**BOARD OF ZONING ADJUSTMENT
STAFF REPORT****Date: December 2, 2013****CASE NUMBER**

5866

New Cingular Wireless PCS, LLC

LOCATION6311 Cottage Hill Road
(220' ± South of Cottage Hill Road, 780' ± East of Hillcrest Road)**VARIANCE REQUEST****HEIGHT:** Height Variance to allow a 150' monopole telecommunications tower in a B-2, Neighborhood Business District.**SETBACK:** Setback Variance to allow the tower within 37.5' of the lease parcel line.**RESIDENTIAL BUFFER SEPARATION:** Residential Buffer Separation Variance to allow the tower within 42.75' of residentially zoned property.**TREE PLANTING:** Tree Planting Variance to allow no tree plantings.**ZONING ORDINANCE
REQUIREMENT****HEIGHT:** The Zoning Ordinance limits structures to a 45' height in a B-2, Neighborhood Business District.**SETBACK:** The Zoning Ordinance requires telecommunications towers to be setback the height of the tower (150') from the lease parcel line.**RESIDENTIAL BUFFER SEPARATION:** The Zoning Ordinance requires a residential buffer separation of 200' or 150% of the height of the tower, whichever is greater (225').**TREE PLANTING:** The Zoning Ordinance requires one tree per every 30' of lease parcel perimet

DETAIL SITE PLAN

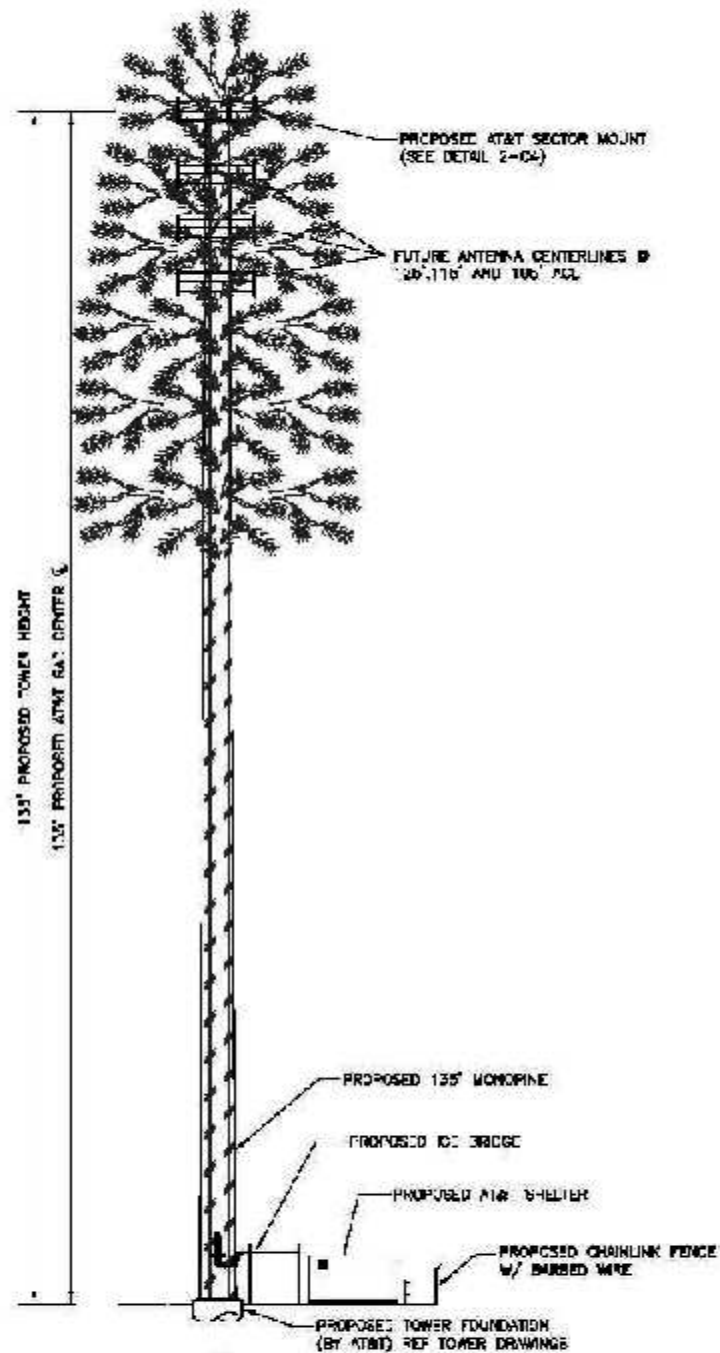
Revisions to the site plan have been submitted which now indicate a 135' high tower is proposed instead of the originally-requested 150' high tower. It would still have the capability of accommodating three additional antenna collocations. In addition to shortening the tower height, the tower is now proposed to be of a tree-simulation camouflage design. It should be noted, however, that the top antenna segment appears to extend above the top of the tower. This should be revised so that no portion of the tower or associated communications equipment extends above the requested 135' height.

The over-all configuration of the proposed lease parcel has been revised to match the revisions required by the Planning Approval and Subdivision reviews before the Planning Commission. A new State law requires lease parcels to be made legal lots of record which required a larger lease area to prevent a land-locked lot being within another land-locked lot. The location of the proposed tower on the site did not change. However, the expanded size of the lease parcel now revises the Setback Request from 37.5' from the lease parcel line to 42.75' from the lease parcel line. The Residential Buffer Separation request remains the same to allow the tower at 42.75' from residentially zoned property, that being the cemetery adjacent to the North of the subject site. The closest residentially-used property is approximately 145' South of the proposed tower. However, since the tower height now proposed has been reduced from 150' to 135', the required Residential Buffer Separation reduces from 225' to 202.5'. The site plan now includes a 6' high wooden privacy fence along the South side of the tower compound as previously recommended. However, as the fence would normally be along the property line, the site plan should be revised to indicate the 6' high wooden privacy fence along the South property line.

The applicant has revised the site plan to indicate tree plantings; however, not all required trees are indicated, and some which are indicated are off the proposed tower lease parcel lot and on the proposed adjacent lot to the South. Urban Forestry has determined that, due to the expanded size of the lease lot area, there is sufficient area provided to accommodate the required tree plantings.

- 1) the tower is limited to a monopole design with a maximum height of 135';*
- 2) revision of the tower elevation to indicate that no communications equipment extends above the 135' tower height;*
- 3) revision of the site plan to provide the 6' high wooden privacy fence along the South property line of the lease area lot instead of the equipment compound;*
